LAND ADJACENT TO BARNSIDE, HOOK LANE, WESTERGATE

RESERVED MATTERS TRANSPORT STATEMENT

Stage 1 Road Safety Audit

RDW/KS/16/1164/RSA1

VISIBILITY SPLAYS FROM PROPOSED ACCESS AND FOOTWAY DESIGN

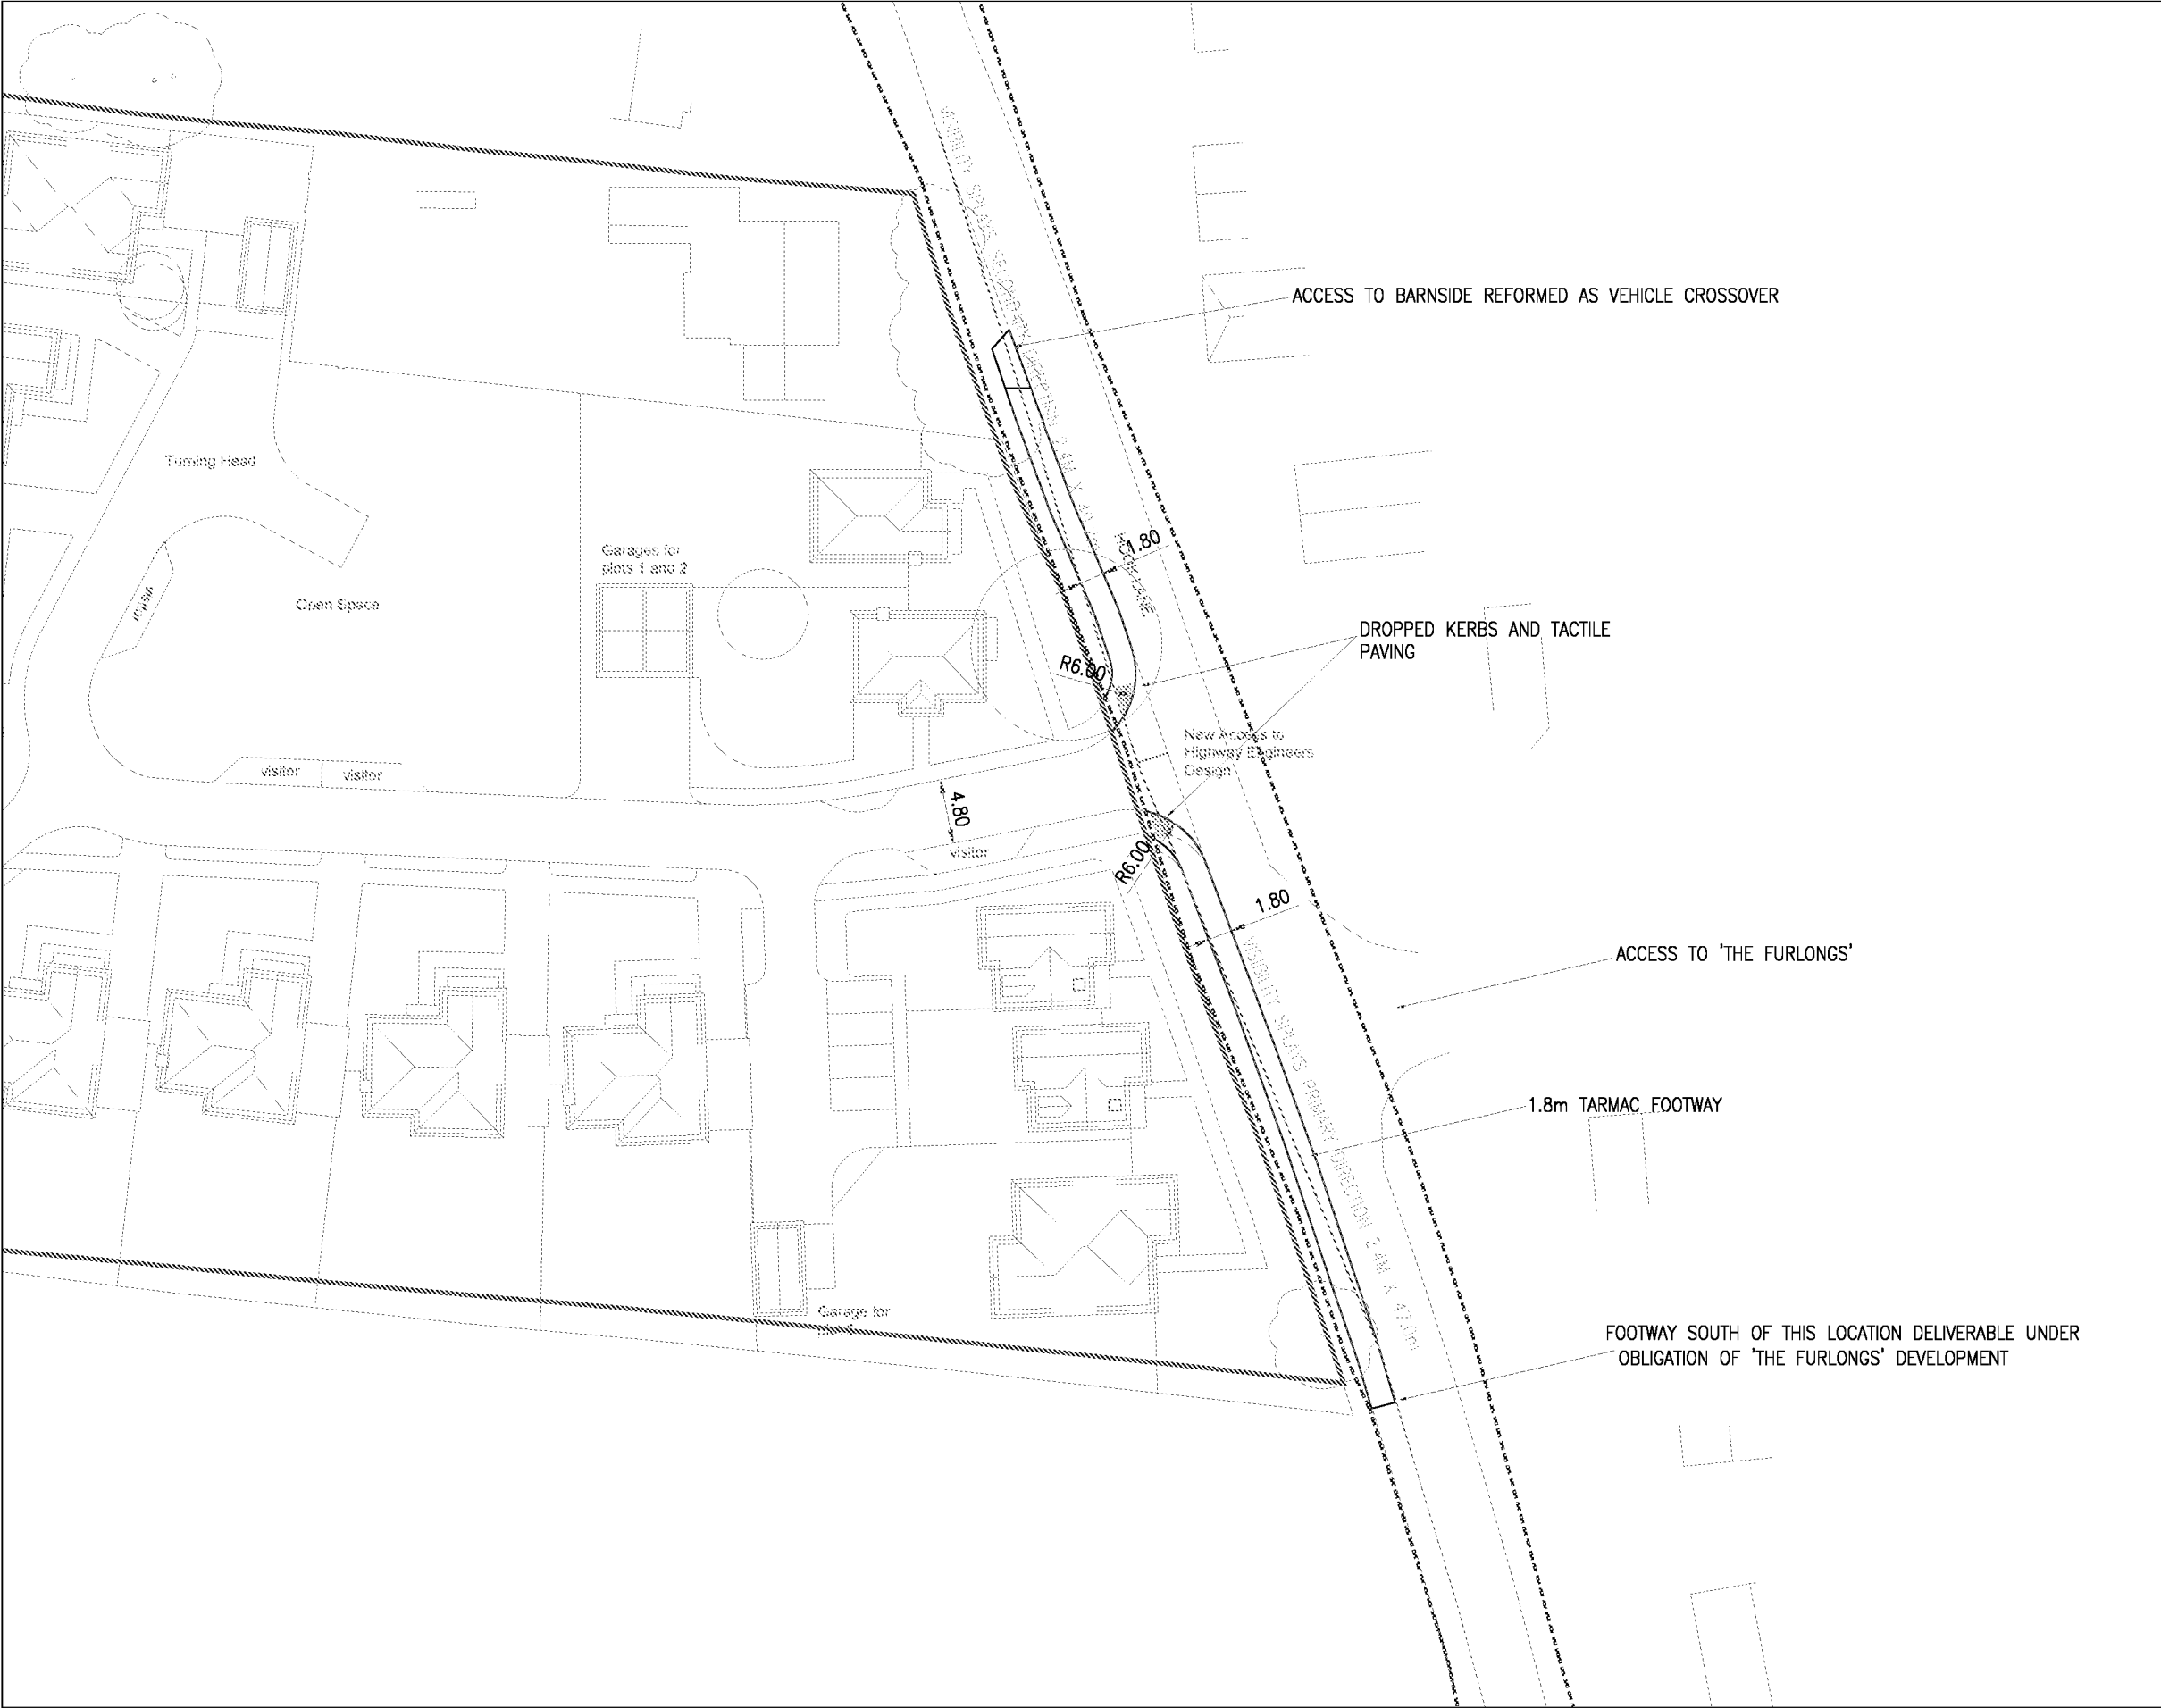
2.7 Problem 3.2: It seems unclear how the proposed footways on the western side of the road travelling both north and south terminate. There is no indication given as to how pedestrians are to enter the carriageway and safety concerns have been raised for pedestrians having to travel in the road.

2.8 Problem 3.3: Lack of clarity on whether the footway on the eastern side of Hook Lane continues into development, as the supplied design drawings show the footway leading into the development terminating approximately 4m into the access.

Problem 3.4: Telegraph pole in area of footway on the western side of proposed crossing over Hook Lane, this will obstruct footway users. It is recommended that the existing telegraph pole is relocated to a position that will not obstruct the footway users.

The Audit Team noted an existing telegraph pole in the area of the proposed footway adjacent to the crossing on Hook Lane. This will obstruct footway users.

Existing vegetation to the south of the pedestrians crossing on the western side of Hook Lane is likely to obstruct visibility to / from pedestrians using the crossing. This could result in vehicles to pedestrian conflicts.

- Solution: The access arrangement drawing attached as **Appendix B** demonstrates how the footway to the south is due to tie in with the existing footway on Hook Lake, whilst the footway to the north is due to terminate at plot 1.

- Solution: It was recommended that this footway be extended into the site to a suitable point where pedestrians and road traffic can safely mix.

- Solution: Plans within **Appendix B** demonstrate how the telegraph pole has been moved to a less obtrusive location on the footway.

- Solution: It is recommended that all vegetation be cleared back to maintain adequate pedestrian visibility splays. **Appendix B** demonstrates that vegetation is suitably cut back in order to avoid intrusion into the visibility splays.

APPENDIX A: LOCATION PLAN

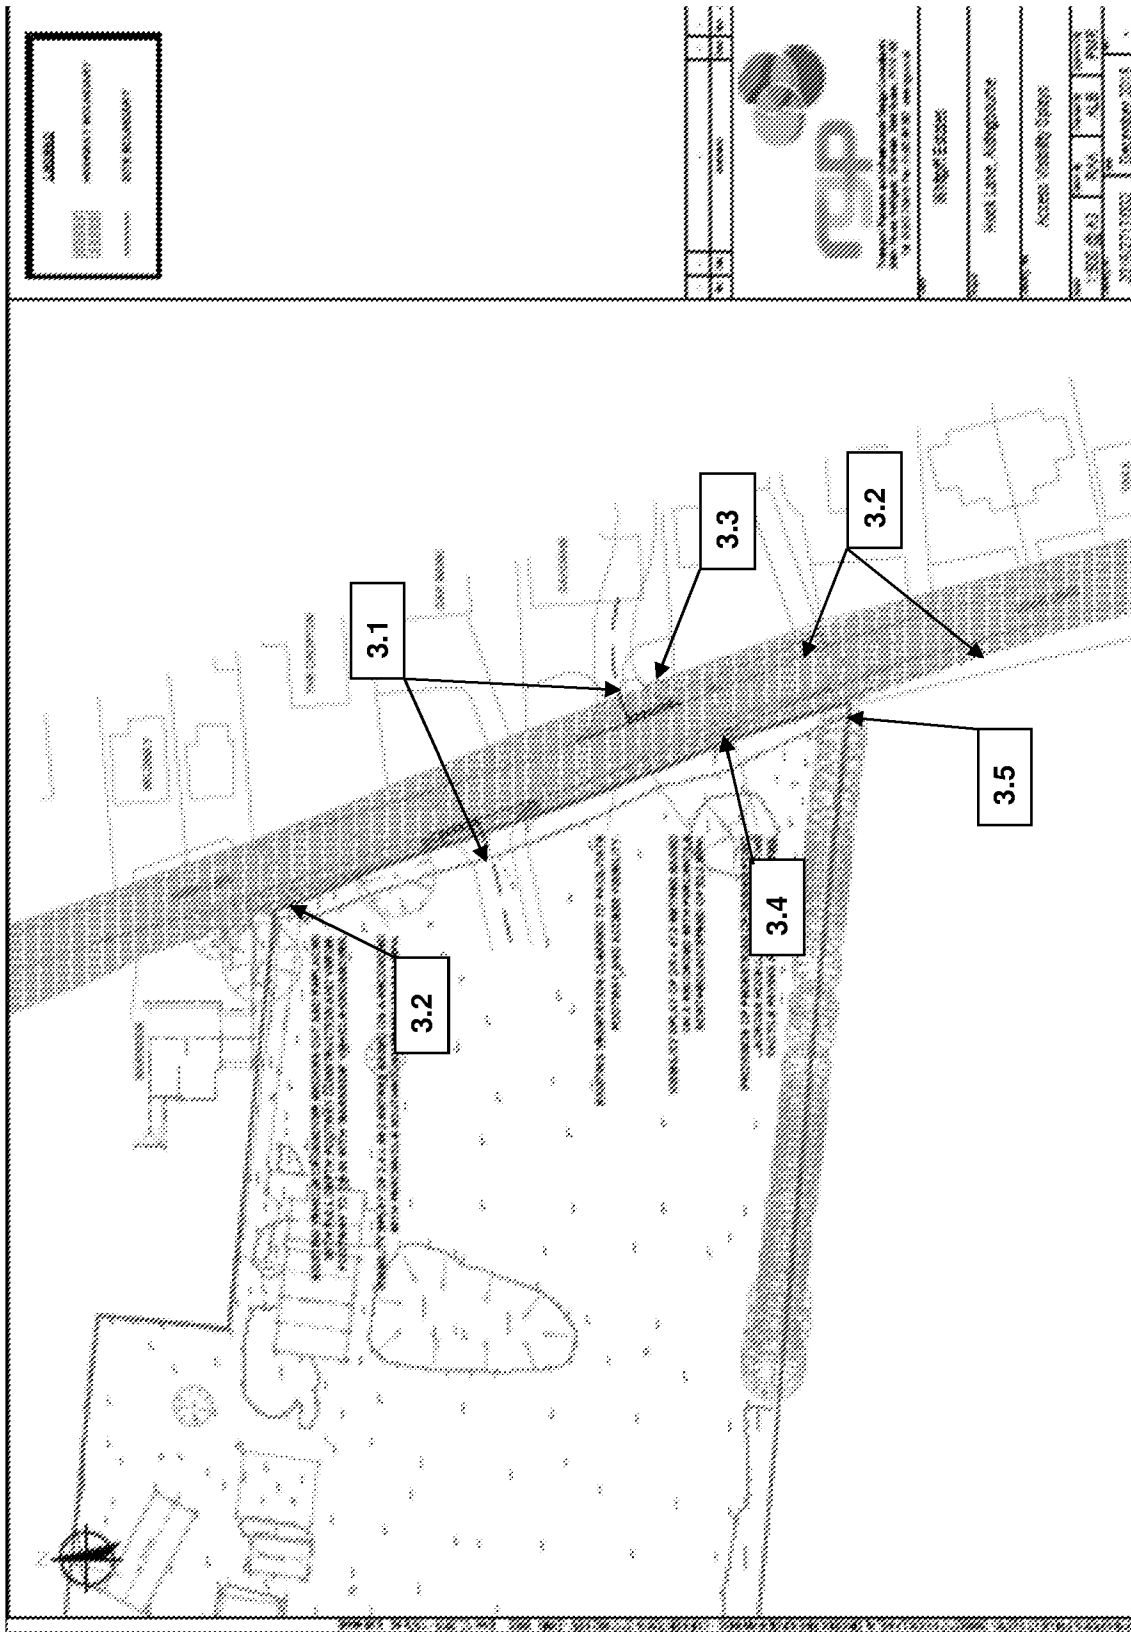
The Audit Team note that both new access roads are less than 5.5m wide and have centre lines proposed. Roads users may therefore be led to believe that they are always able to safely pass opposing vehicles, including long vehicles such as refuse vehicles. This could increase the risk of side to side conflicts.

The supplied design drawings show proposed footways on the western side of the road extending north and south from the development access.

To the north the footways appears to terminate, however no indication is given as to how pedestrians are to enter the carriageway.

To the south the footways are also shown to terminate. Other plans supplied appear to show proposed footways on Hook Lane that these sections will link to however the Audit Team are concerned that should there be a period within which the footways do not form a continuous link then pedestrians will be forced into the carriageway at an unsuitable point or via an unsuitable access, i.e. no dropped kerbs.

The supplied design drawings show the footway leading into the development access on the eastern side of Hook Lane appearing to terminate approximately 4m into the access.

Omit the centre line from the access roads where the road width is less than 5.5m.

Ensure that all footways link to the wider footway network and that where footways terminate pedestrians are given safe and obvious access to and from footways, particularly for visually and mobility impaired pedestrians.

Extend the footway into the site to a suitable point where pedestrians and road traffic can be safely mixed.

Relocate the existing telegraph pole to a position that will not obstruct footway users.

Clear back all vegetation to maintain adequate pedestrian visibility splays.

Problem no. in safety audit report	Problem accepted (yes/no)	Recommended measure accepted (yes/no)	Alternative measure (detail description)
3.1	No	No	The application of guidance regarding centrelines is not applicable at priority road junctions. The centre line assists vehicles with their positioning on egress in order to avoid the carriageway being obstructed. Drawing 2015.2717.001 demonstrates that standard car sized vehicles can concurrently turn in and out of the access and that a large service waiting at the access can be passed by a standard car sized vehicle.

3.2	No	No	A dropped kerb crossing is provided just south of the access linking with the footway infrastructure on the opposite side of the carriageway associated with the Hallam Land development. The short section of footway to the north is provided to collect pedestrians leaving the two properties along the site frontage. As there is no footway proposed opposite this section of footway no formal dropped kerb crossing is provided, thereby encouraging pedestrians to use the formal crossing provided.

The new southern section of footway to the south would tie in with the new footways proposed on west side of the carriageway, which will come forward as part of the Hallam Land application. The northern section of the footway would tie in with the existing driveway at its far end which would be formalised into a vehicle crossover arrangement. The dropped vehicle crossover would serve pedestrians and vehicle movements into the carriageway.
3.3	No	No	It is proposed that the adjacent Hallam Land development uses a shared surface arrangement. A dropped kerb into the carriageway is proposed, along with appropriate road surfacing to indicate shared use.
3.4	Yes	Yes	-
3.5	No	No	Vegetation would be removed through the implementation of the footway. Demonstration of the required pedestrian visibility splay is provided in Drawing 2015.2717.002 attached to the Transport Statement.
